DEVELOPMENT REVIEW BOARD REPORT

CASE NUMBER/ PROJECT NAME	28-DR-2000#4 Portales Residential		
LOCATION	5000 N. Portales Place		
REQUEST	Request approval of modification to elevations and site plan approved in Case 28-DR-2000#3.		
OWNER	Portales Place Property LLC 602-510-3329	ENGINEER	DEI Professional Services LLC 602-954-0038
ARCHITECT/ DESIGNER	V V G Associates LLC 602-716-5611	APPLICANT/ COORDINATOR	Brian Agersea Grace Communities LLC 602-469-5789
BACKGROUND	<p>Zoning. The site is zoned D/RCO 2 PBD DO (Downtown Regional Commercial Office Type 2 Development Standards Planned Block Development Downtown Overlay).</p> <p>Context. The site is located on the south side of Chaparral Road, north of Goldwater Boulevard, and west of Scottsdale Road at the northwest corner of the Portales Master Planned Development.</p> <p>Adjacent Uses:</p> <ul style="list-style-type: none">• North: Single-family residential; zoned R1-7.• South: Unimproved, approved for condominiums, office, and retail use; zoned D/RCO-2 PBD DO.• East: Under construction for office use; zoned D/RCO-2 PBD DO.• West: Single-family residential; zoned R1-7 and R1-10.

Scottsdale Development Review Board Report
Case No. 28-DR

NEW CONSTRUCTION
5000 Portales Place
Scottsdale, Arizona
SITE PLAN

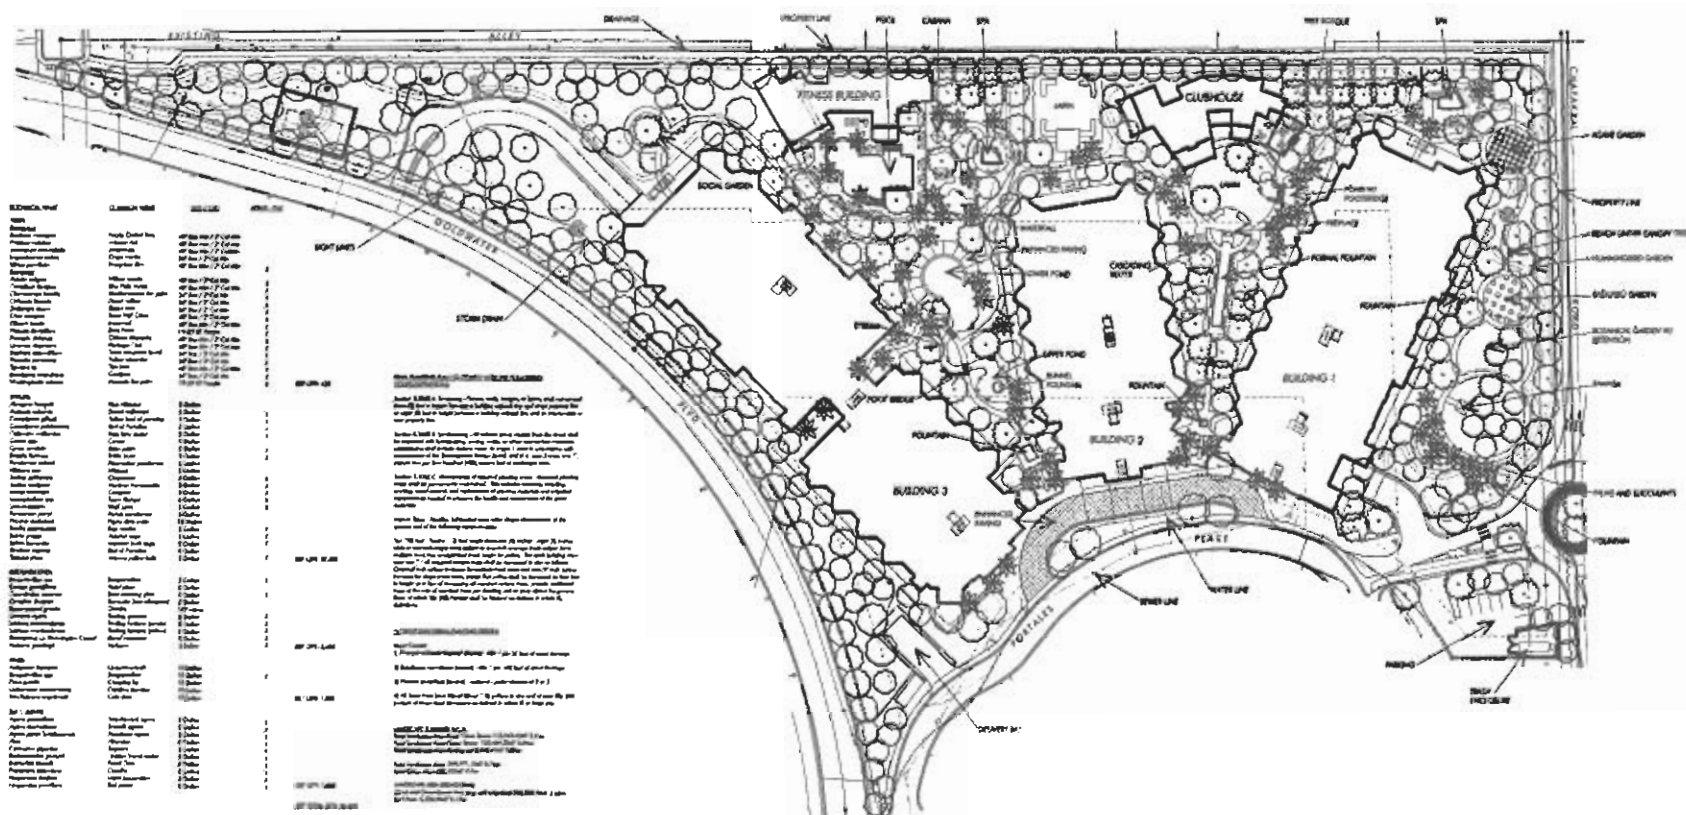
The site plan shows the three multi-level buildings with their height stepping from five stories on the eastern side to two stories at the west side of the buildings, in conformance with zoning height setback requirements. Two, one-story buildings are shown on the western side of the site and these are the clubhouse and fitness buildings. These buildings are oriented so that they provide a buffer between the neighboring single-family residences to the west and the outdoor activity areas to the east. A small pool and outdoor grassy area at the northwest side of the site are not buffered by buildings but are set about 10 feet lower in elevation compared to the adjacent single-family residential development.

- A. *The developer shall revised the building height of the elevations to comply with Zoning Ordinance and Case 76-ZN-85#3 as indicated on the site plan submitted by VVG Architecture and Planning with a date provided on the plans by City Staff of 10/27/05*

Conceptual Wall Detail 1/2"

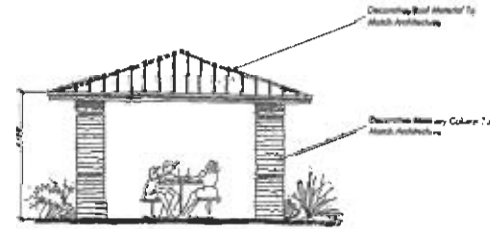
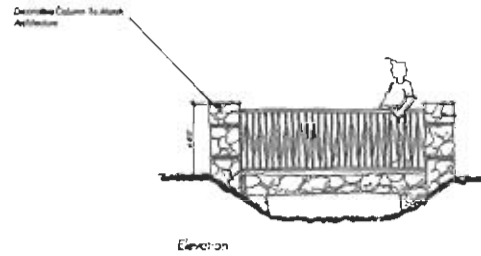
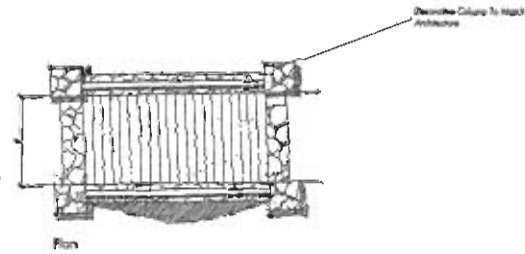
8. Dooley wall fencing shall not be allowed.
9. The Ramada, walls, fences, and pedestrian bridge architectural elements shall match the architectural color, materials and finish of the building(s).
